Groundwater Management Plan

Santa Clara River Valley Groundwater Basin, East Subbasin

CASTAIC LAKE WATER AGENCY

December, 2003

Figure 5-3

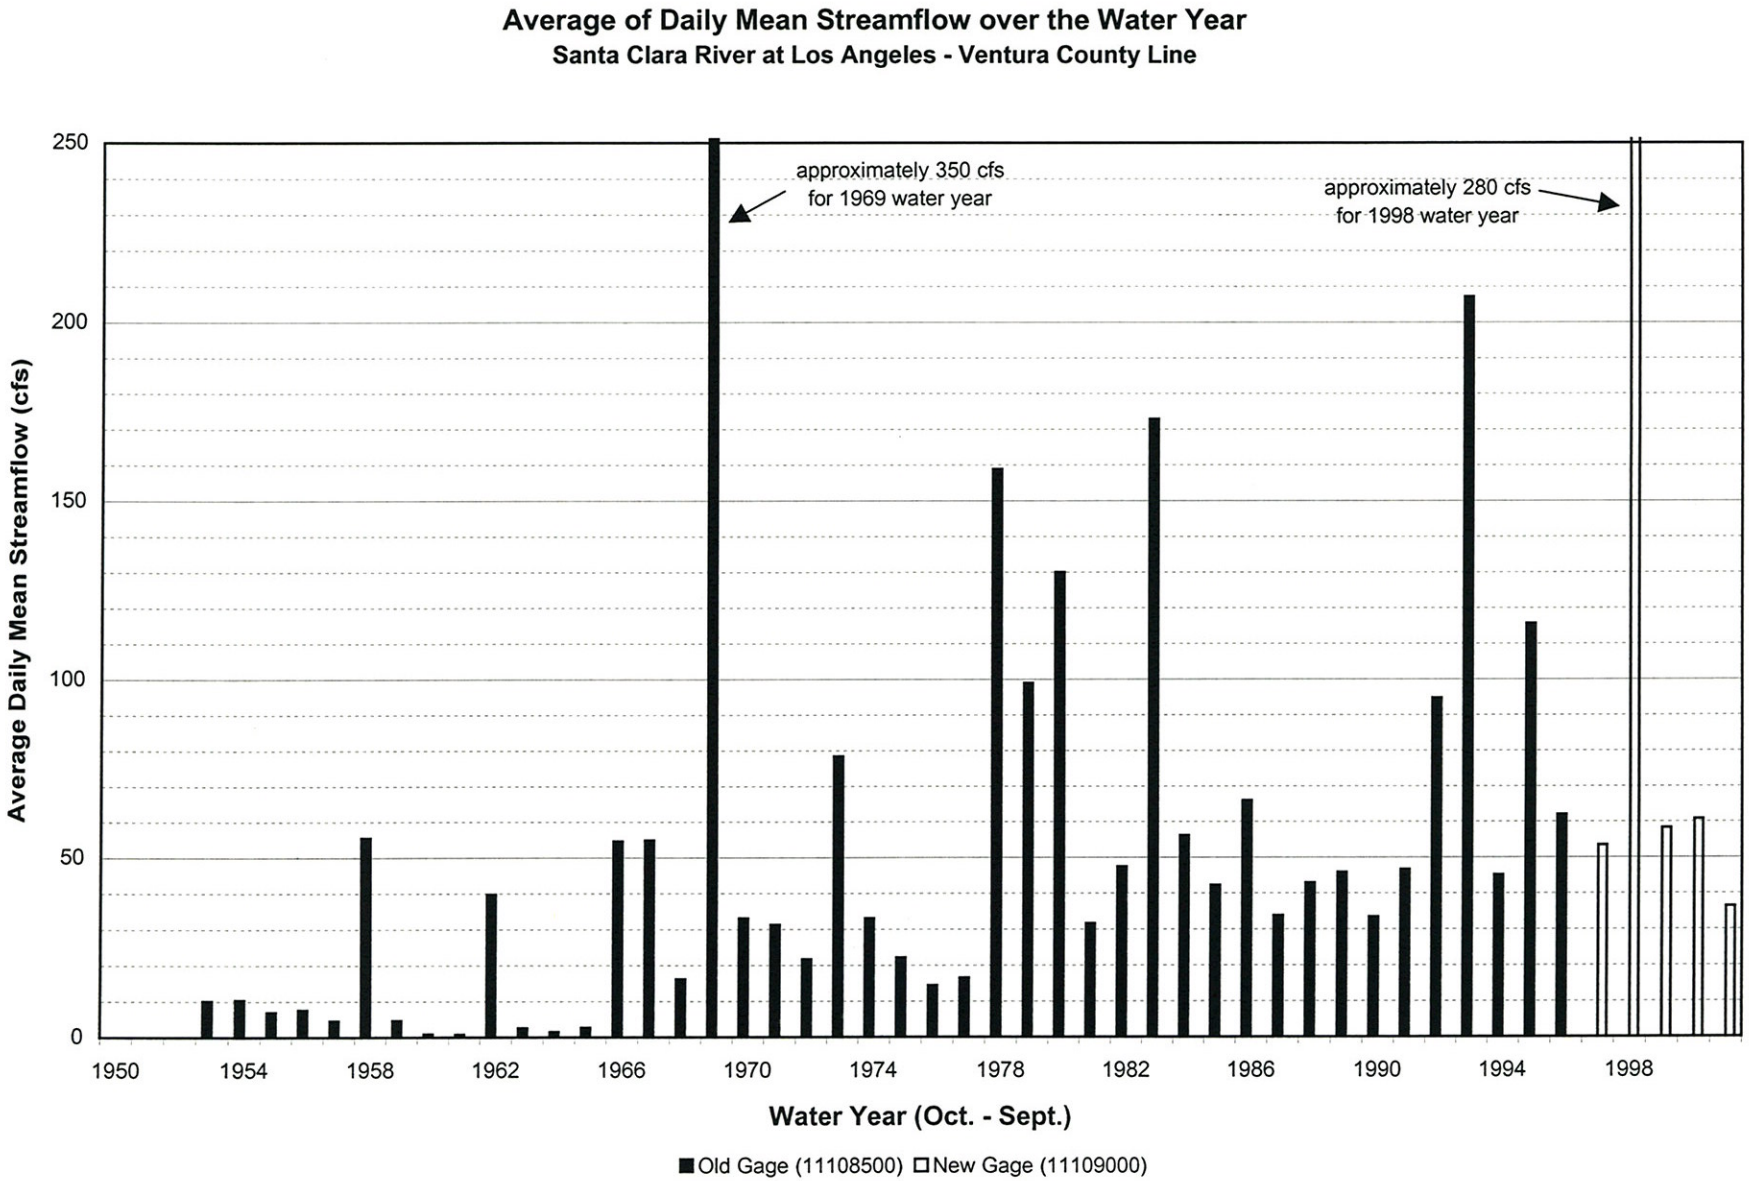
Figure 5-3. The average daily mean streamflow data appears to be shifted one year on the histogram graph. As an example to show the error, the histograms suggest that there were high flow years in 1968 and 1997. The high flow years were actually 1969 and 1998;

Figure 5-4

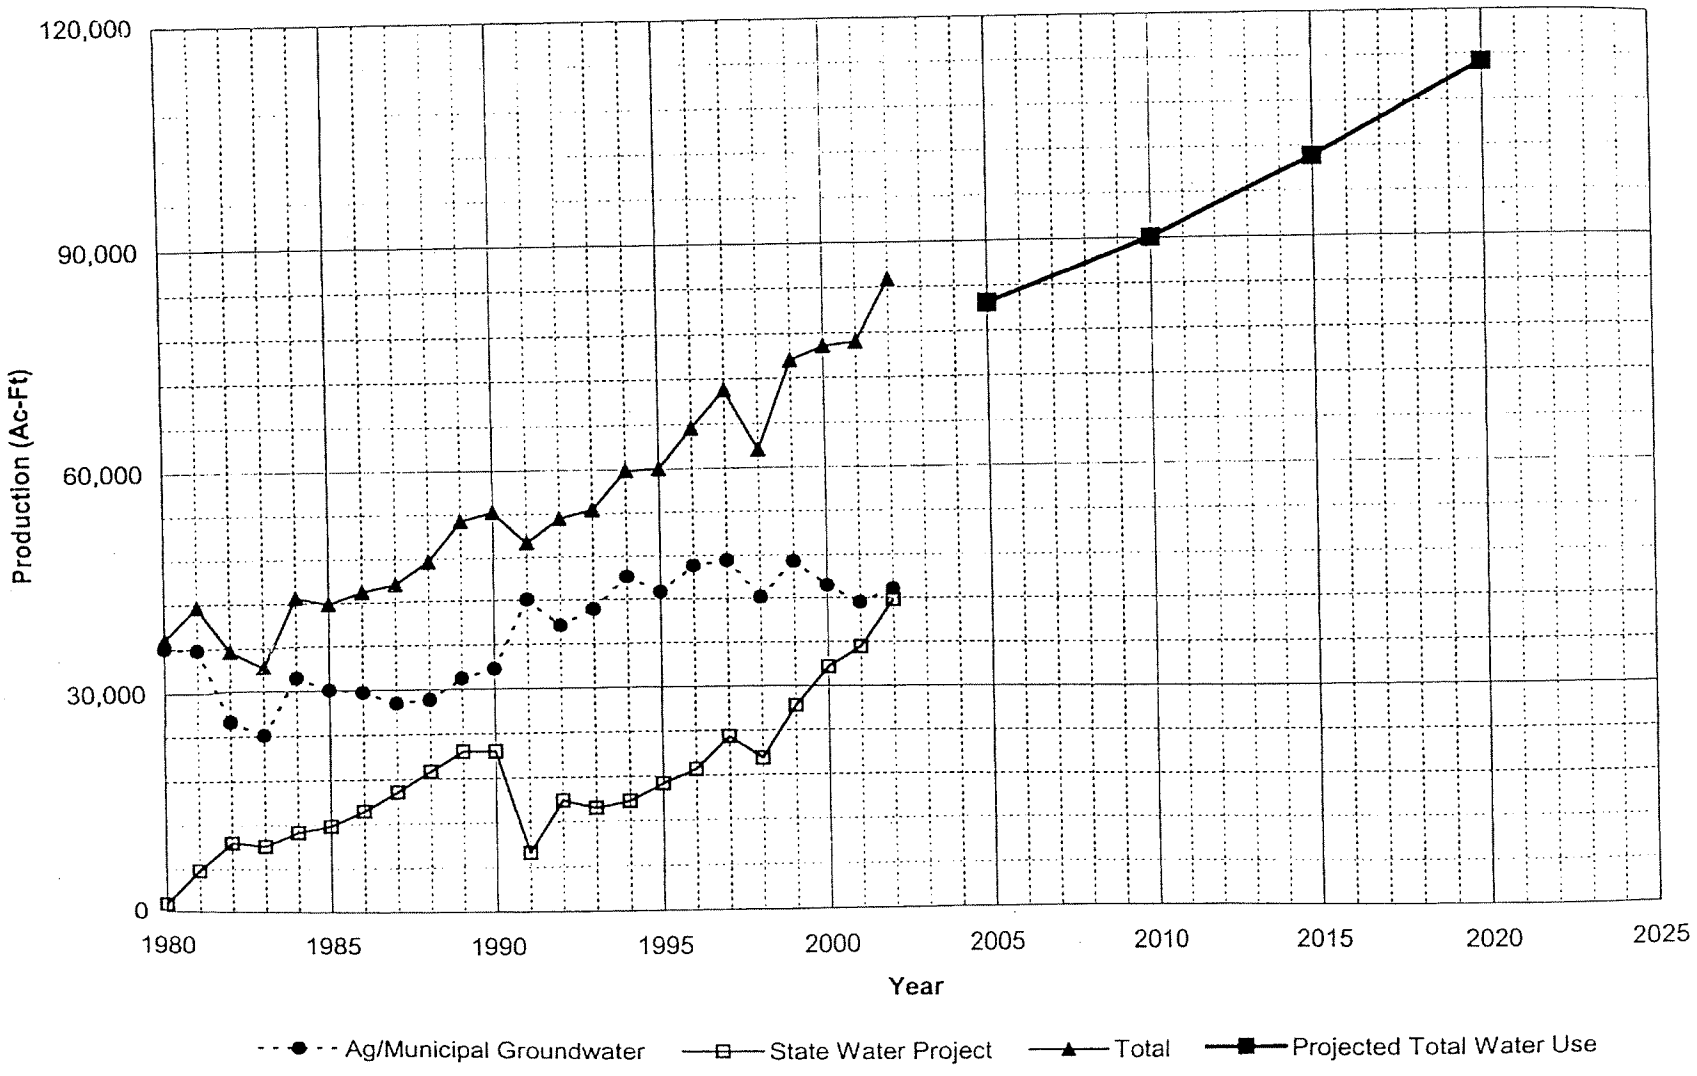
The SWP water received in 1991 is erroneous. The chart indicates 8,000 a/f. It is incorrect. CLWA only received 10% of its then allocation 54, 200 a/f. The 10% was received in January and the plant shut down in March. See Exhibit A. It should be noted that this is a state water project interruption for months, not a reduction.
